Koichi Hirano

Office Action Summary	Application No. 10/589,973	Applicant(s) HIRANO, KOICHI	
	Examiner KEEGAN GUMBS	Art Unit 4128

DETAILED ACTION

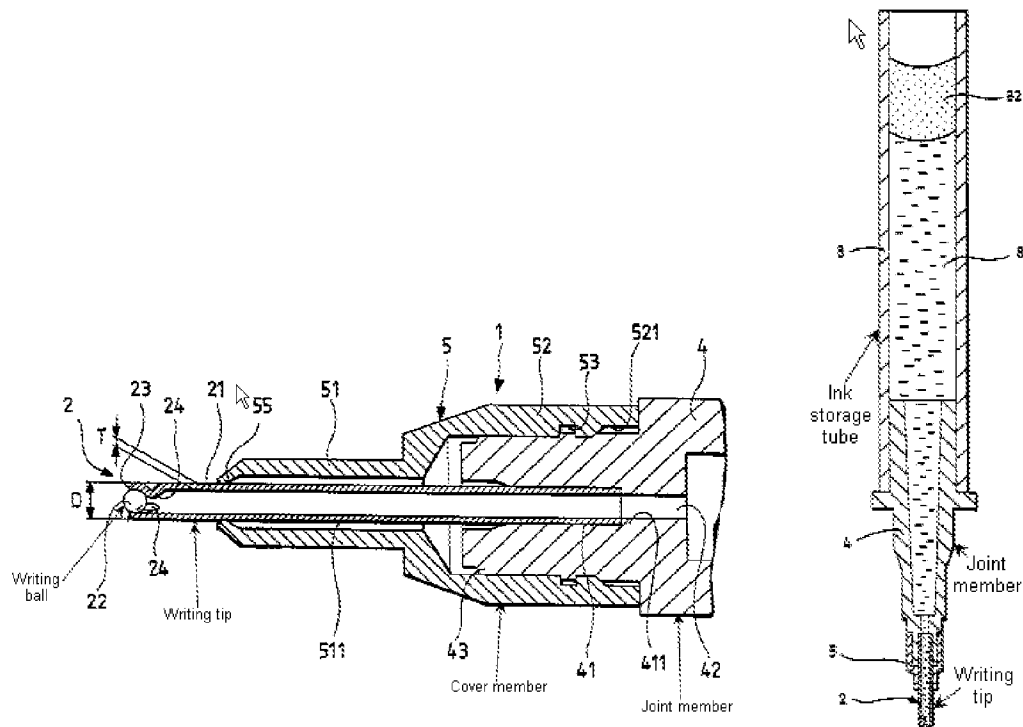
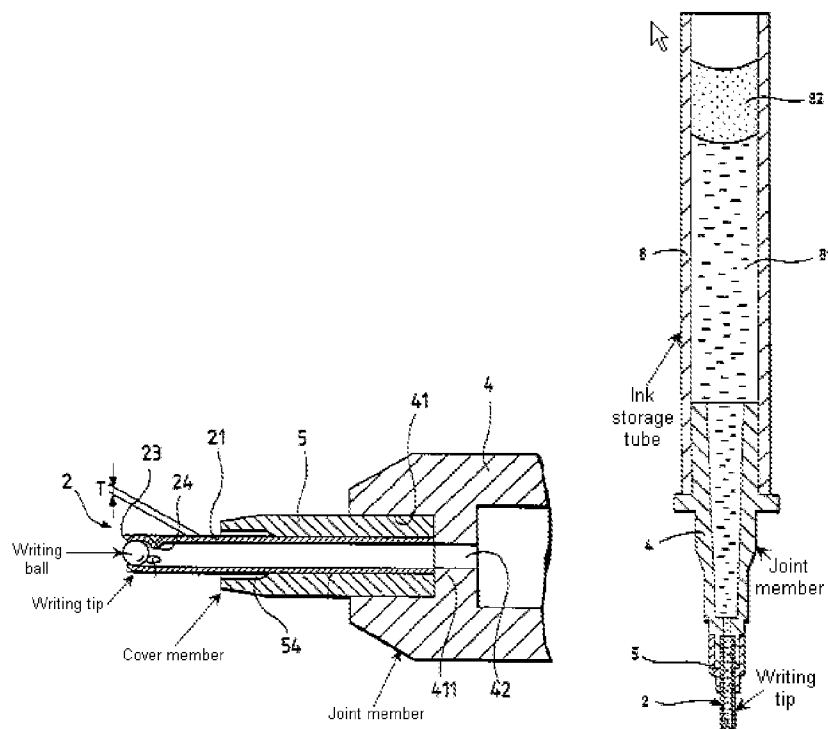
Regarding claim 1, Sekine discloses a ball-point pen having a writing tip which rotatably supports a writing ball, an ink storage tube of which ink is stored, a joint member, and a cover member fitted and mounted along the perimeter surface of the joint member (*see annotated figures above*). Even though Sekine does not specifically disclose that the cover member is arranged in dimensions so as not to approach within 0.2 mm of the writing tip, it, however, would have been obvious to one of ordinary skill in the art at the time the invention was made to use such optimum value since simply

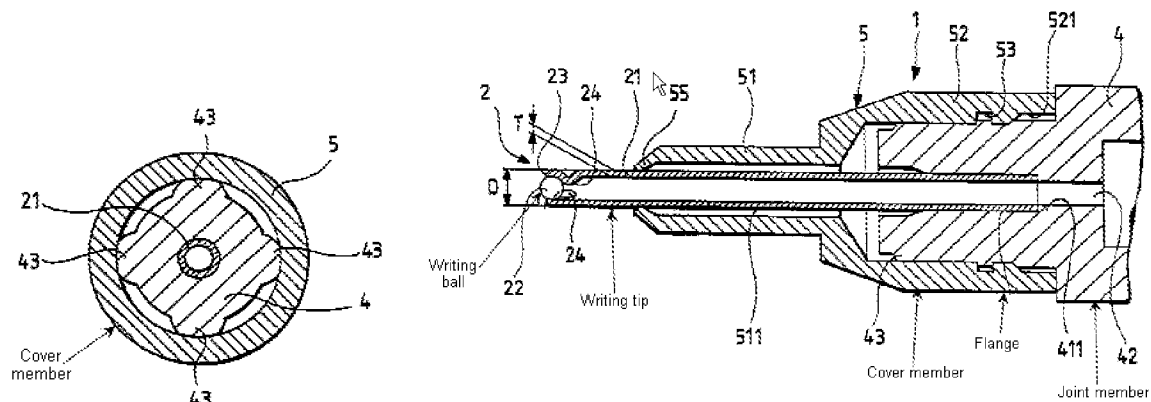
Regarding claim 2, Sekine discloses a ball-point pen having a writing tip which rotatably supports a writing ball, an ink storage tube of which ink is stored, a joint member, and a cover member fitted and mounted along the inside of a mounting hole formed at the joint member (*see annotated figures above*). Even though Sekine does not specifically disclose that the cover member is arranged in dimensions so as not to approach within 0.2 mm of the writing tip, it would have been obvious to one of ordinary skill in the art at the time the invention was made to use such optimum value since
